Addendum No. 1

Project Name: N5001(1)1,2&4 Road Improvement Project in Toadlena/Two Grey Hills, NM

Owner: Navajo Division of Transportation

3. Plans: Sheets 98-102 have been revised to clarify dimensions for Bridge N213 per question received. Replace plan sheets 98-102 and refer to the question-and-answer section.

GRS-IBS-DETAILS
SHEET 4 OF 4

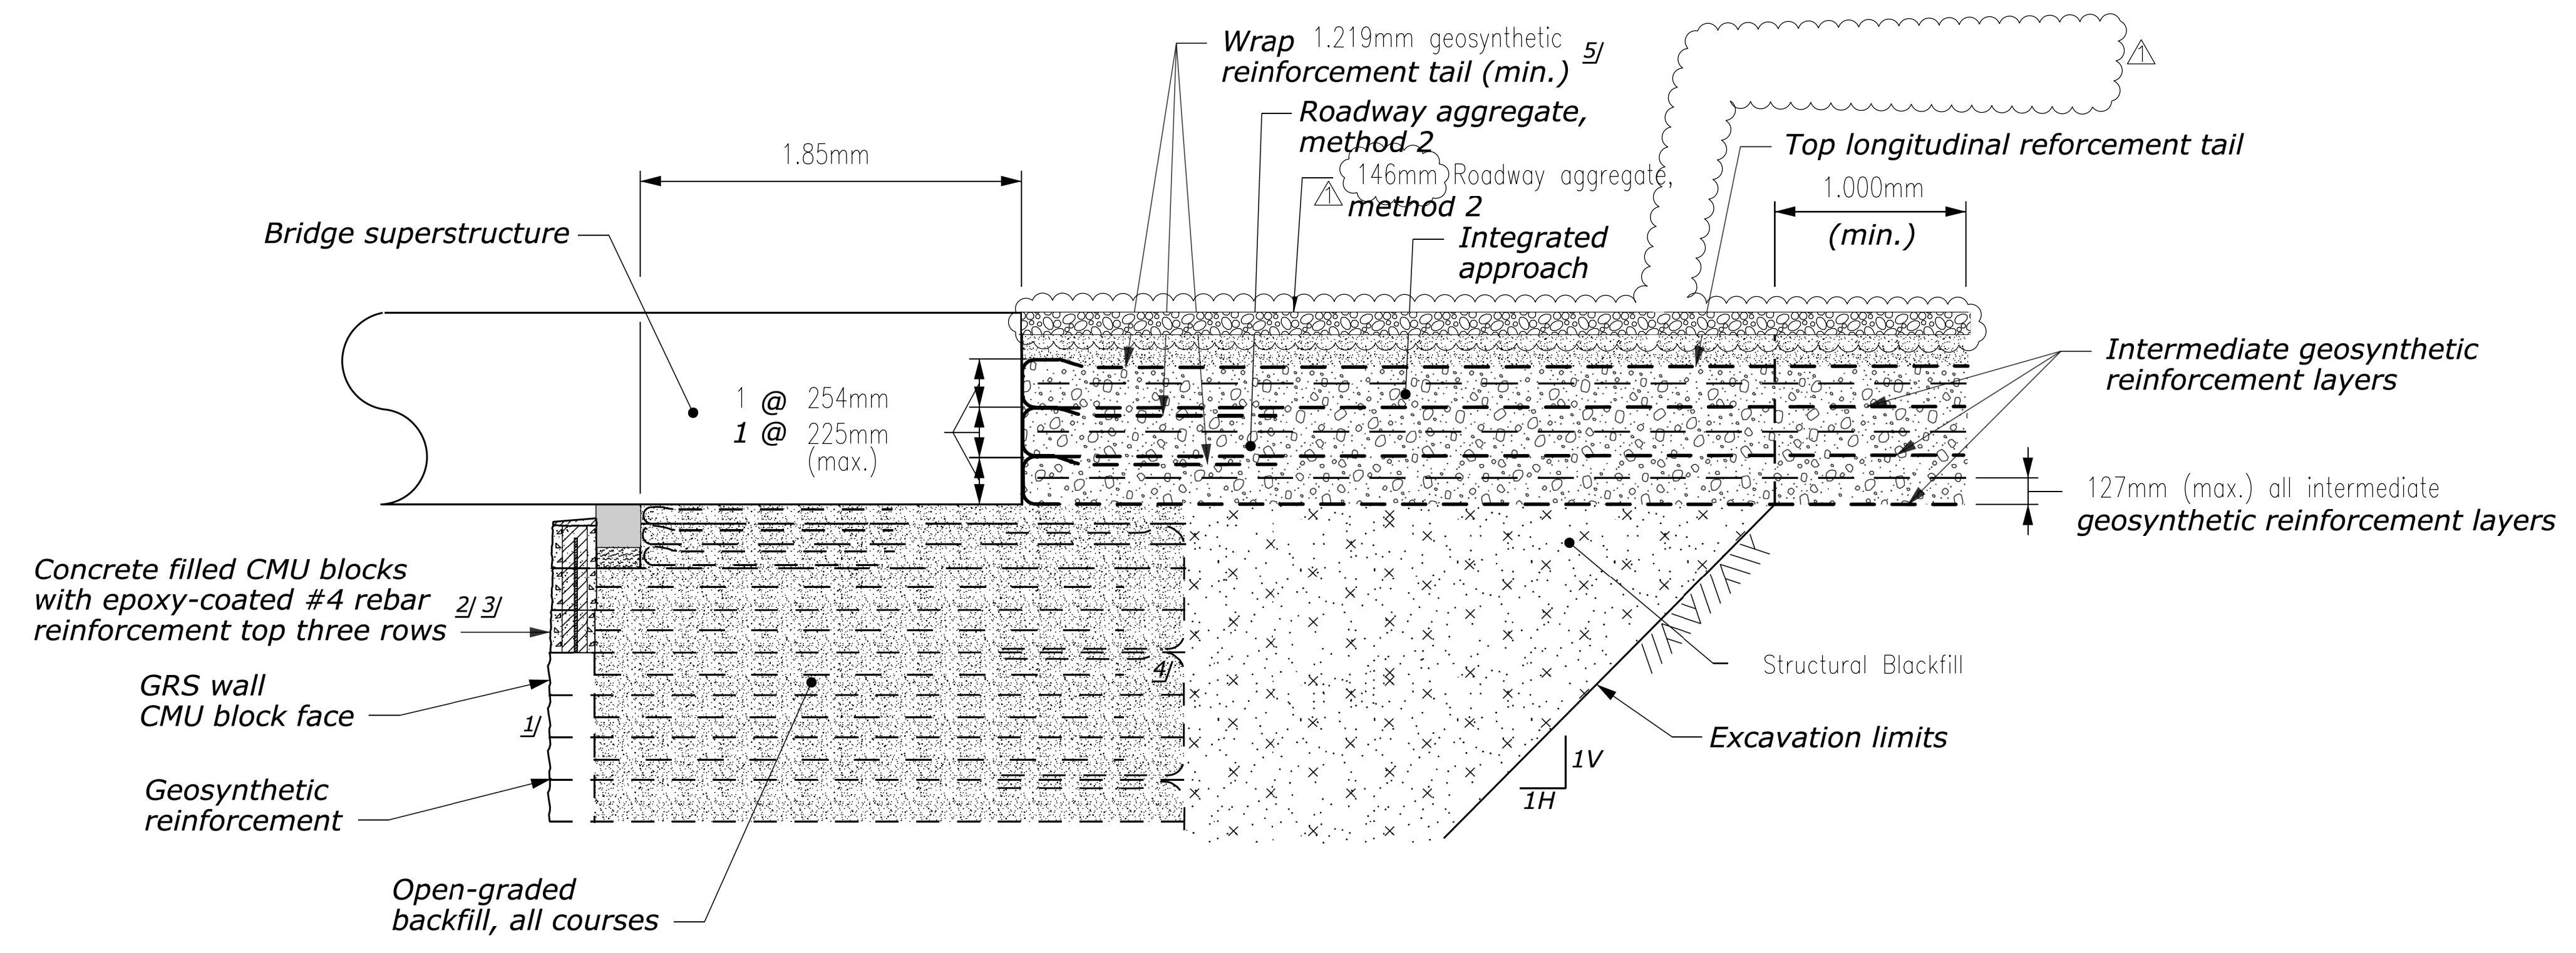
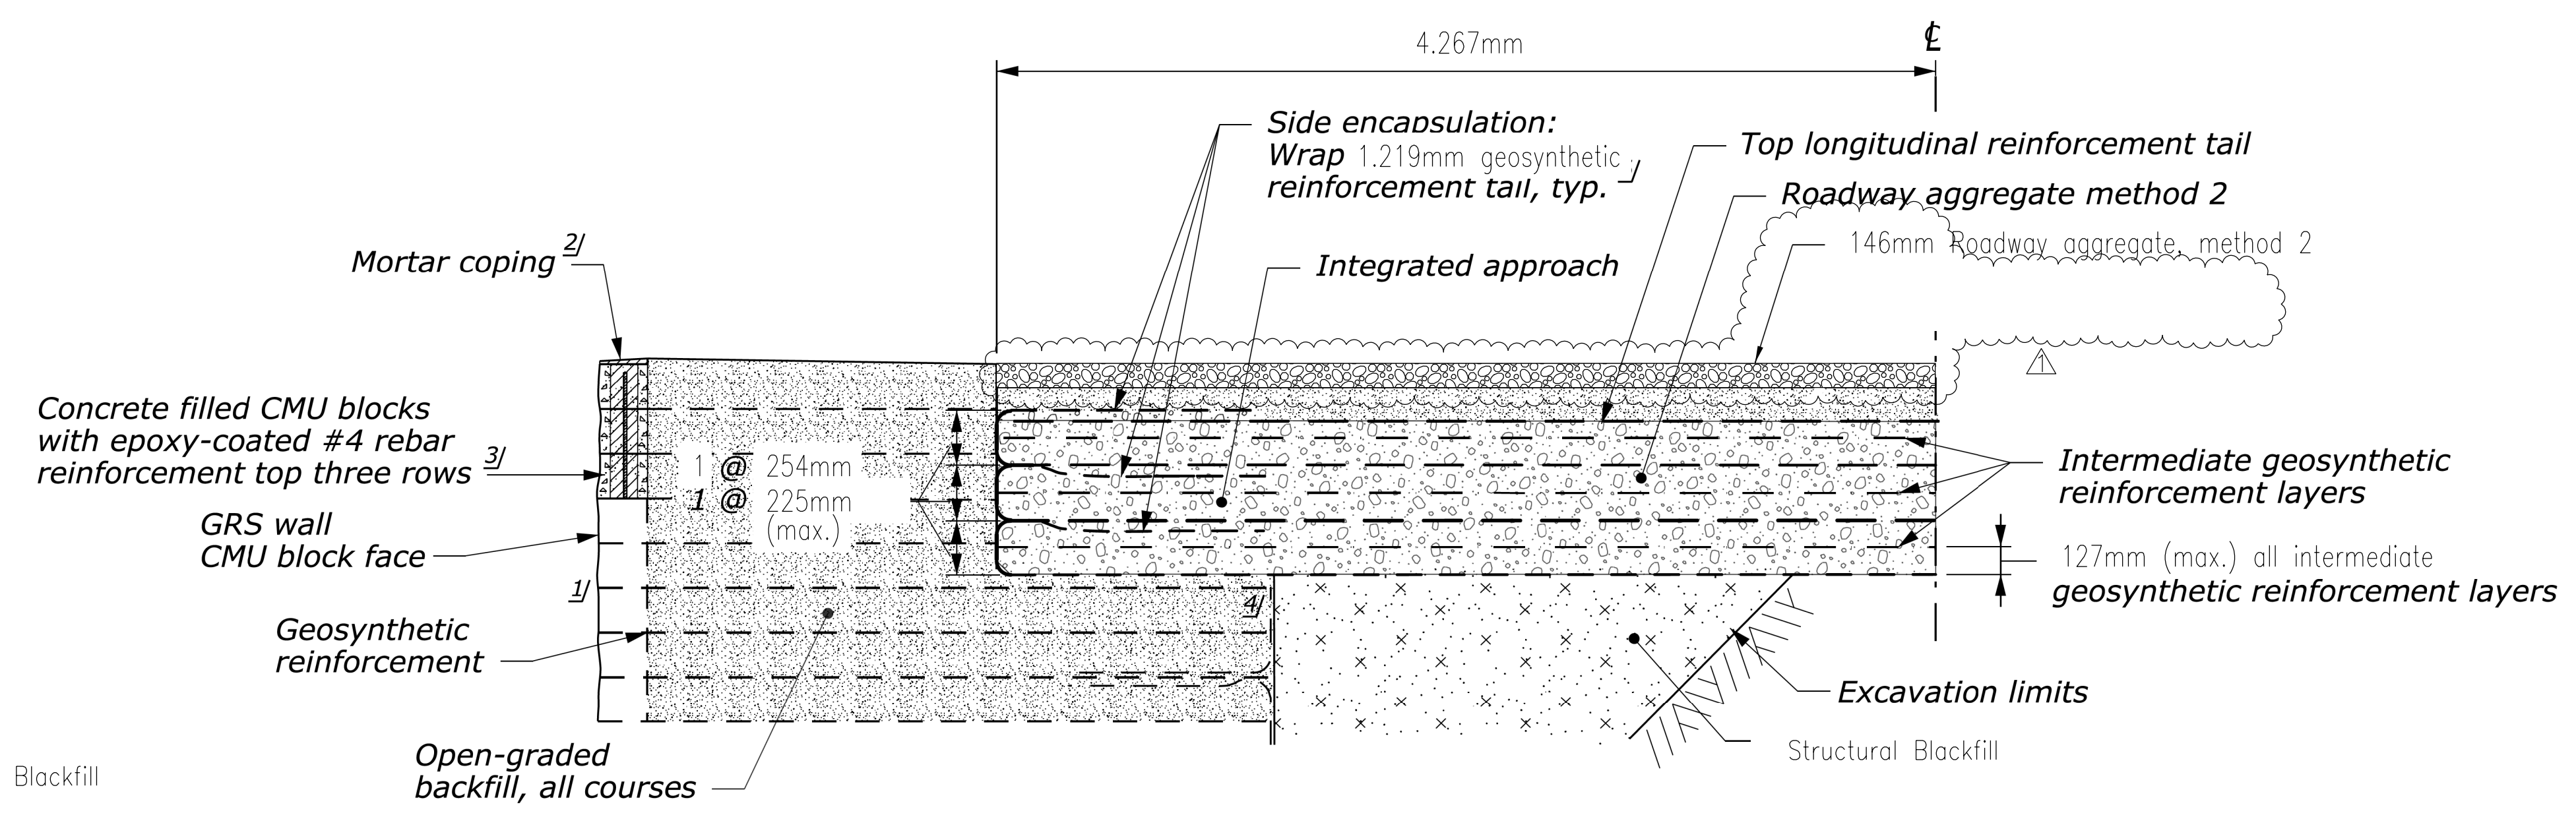
Under Part III-Outline of Request of Proposal, Section B.-Qualifications And Capability, part "e" requires the firm that is providing the proposal to provide documentation showing they are properly licensed or registered in the State of AZ. This project is located in NM, does this requirement still apply?	No. Licenses and registrations for the State of Arizona are not required. This requirement should be New Mexico . The Request for Proposal language was corrected to reflect this clarification.
How will the geosynthetic in the integrated approach slab be paid for on plan sheet 102?	The geosynthetic in the integrated approach slab is to be paid under bid item number 57401-0000, GRS-IBS, Geosynthetic Reinforcement.
Will the department please clarify the dimensions for the integrated approach slabs. Section C-C on plan sheets 101 & 102 have different dimensions listed for the same drawing.	Integrated approach slab shall have 146 mm roadway aggregate over the GRS reinforcement. Plan sheets 101 & 102 have been revised to reflect this change.
